January 30, 2006

SUBJECT: Dixie Waste Service -Waste Gasification/Thermal Oxidizer
AIRS ID Number: 0290016
Response to January 20, 2006 Request for Additional Information

This letter is presented in response to the letter received from the Florida Department of Environmental Protection (FDEP) to Mr. Anthony Fraccalvieri of Dixie Waste Service LLC (Dixie Waste), dated January 20, 2006, requesting additional information to continue processing the air construction permit application. Golder Associates Inc. (Golder), on behalf of Dixie Waste, has prepared the response presented below.

INTERNATIONAL ENVIRONMENTAL TECHNOLOGIES, INC. Hedley Plaza, Suite 200 100 Leominster Drive Leominster, MA 01453			
DATE	11/14/97	SCALE	NOT TO SCALE	REVISION	CRD
PROCESS FLOW DIAGRAM					
DESIGNED BY	CRD				
DESCRIPTION	BY	0537608/4.4/DWS-FI-C2a

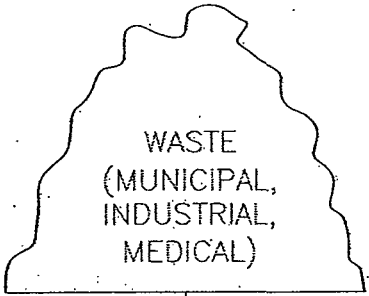
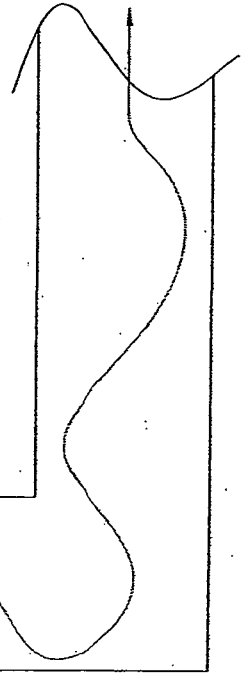
FDEP Comment 15 – In the process flow diagram, please include the following:

- a. For each component, identify the inlet/outlet temperature (degrees F), inlet/outlet flow rate (acfm and scfm), and pressure drop across the component (inches w.c.): primary gasification cell; air mixing chamber; thermal oxidizer; acid gas scrubber; and the stack outlet.
- b. The diagram indicates that natural gas will be used in the primary gasification cell as well as the thermal oxidizer. Elsewhere in the application, propane and diesel are identified for use in the primary gasification cell and propane for use in the thermal oxidizer. Please clarify.
- c. Identify the location of the induced draft fan.

- a. The specific design requirements requested will be provided to FDEP once the final design is completed but no later than 30 days prior to construction.
- b. Propane gas is the primary fuel that will be utilized in the primary and secondary chambers. Diesel fuel had been included in the application as a back-up fuel to commence the combustion process. However, diesel fuel is no longer intended to be used. Revisions to page 18 are attached as part of this response to remove diesel fuel as an auxiliary fuel (Attachment 2). No natural gas will be utilized for this facility.

Although the process flow diagram indicates the use of natural gas only propane will be used. A revised flow diagram has been included as part of this response.

ATTACHMENT DWS-FI-C1a. PROJECT AREA
 DIXIE WASTE PLANT, DIXIE COUNTY, FLORIDA

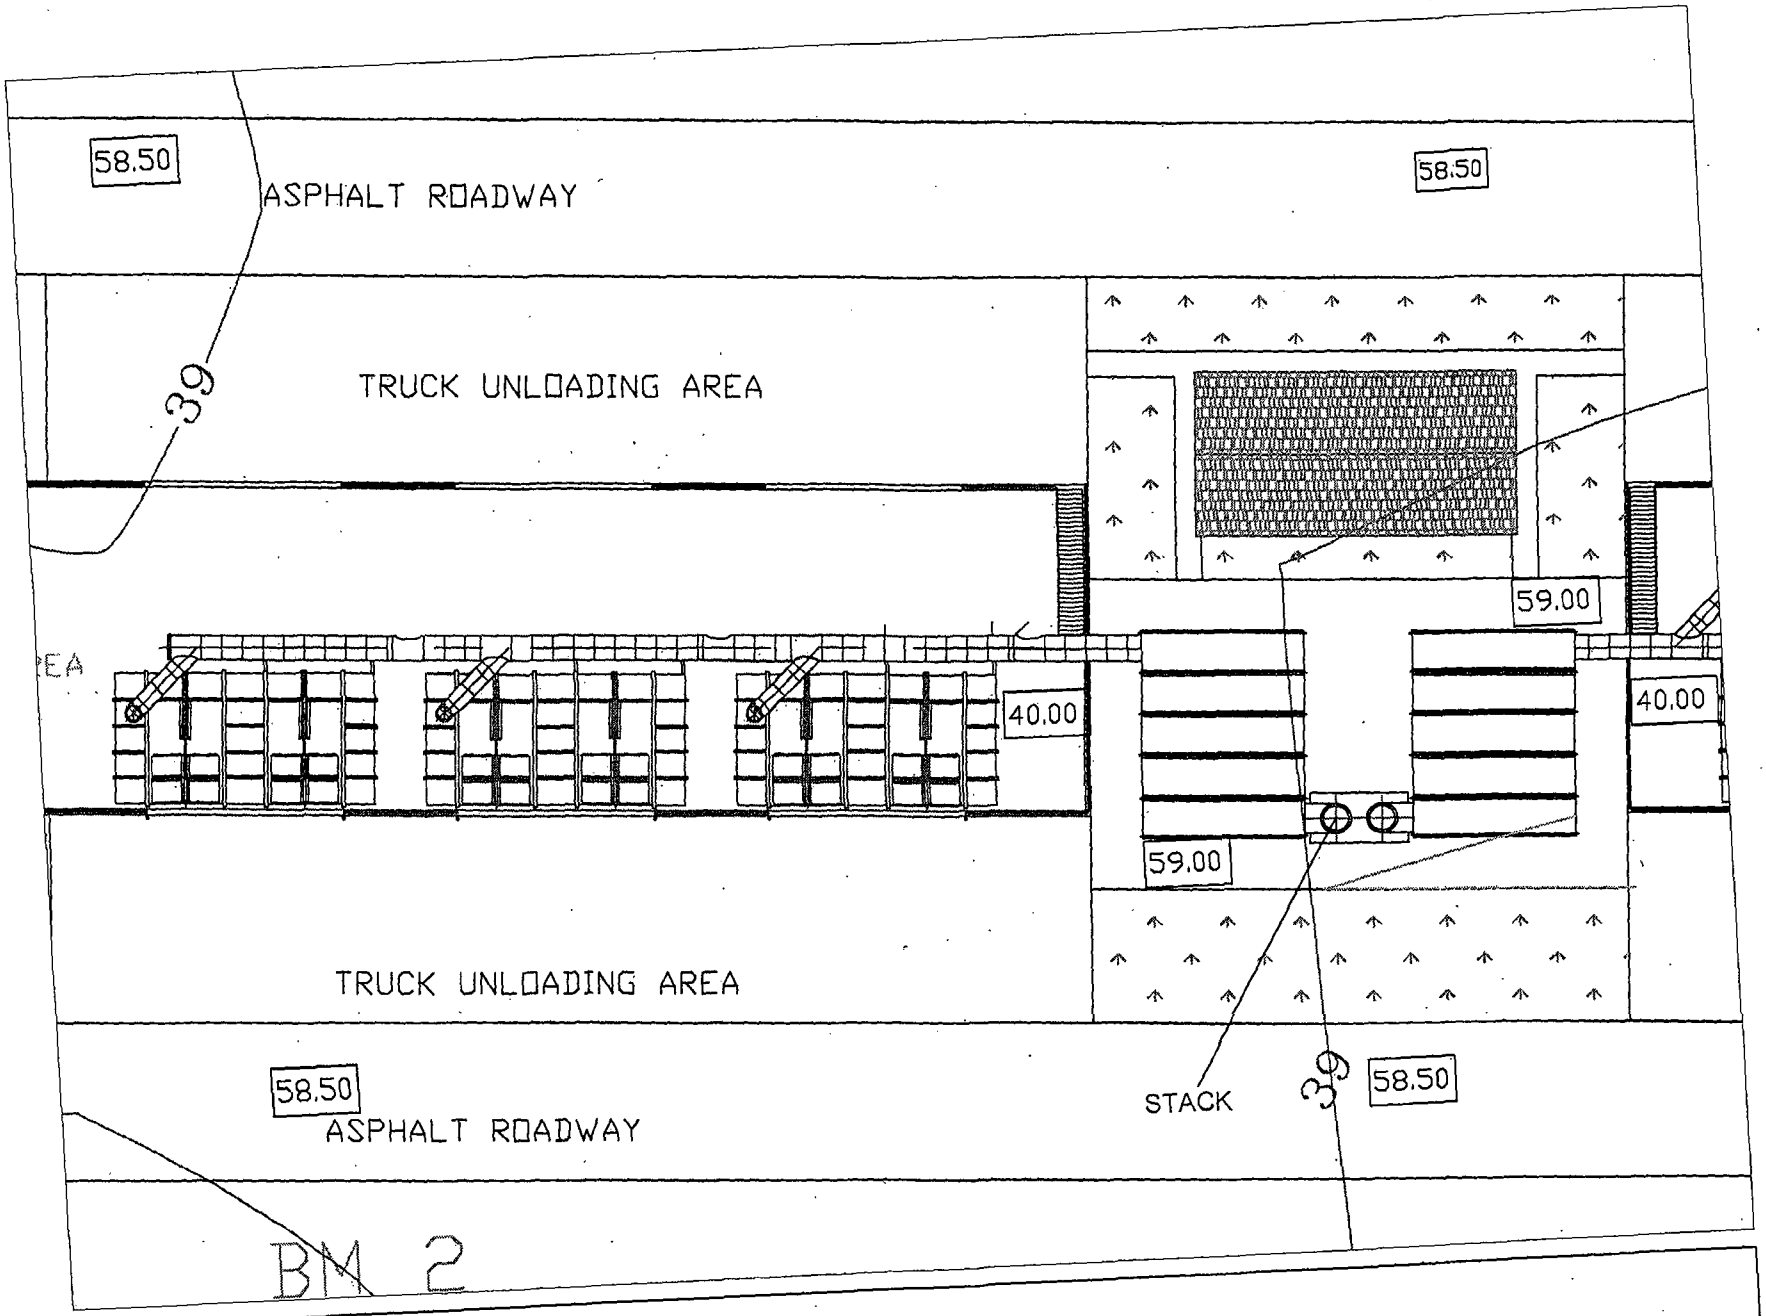
FDEP Comment 20 – Please identify each component of the proposed system in the project area diagram. Please clarify whether the drawing shows that the system will have 3 cells or 6 cells.

The drawings provided indicate the proposed 3 cells that will be constructed. An approximate location of the scrubber is provided. The applicant will provide detailed design information including drawings and specifications 30 days prior to construction.
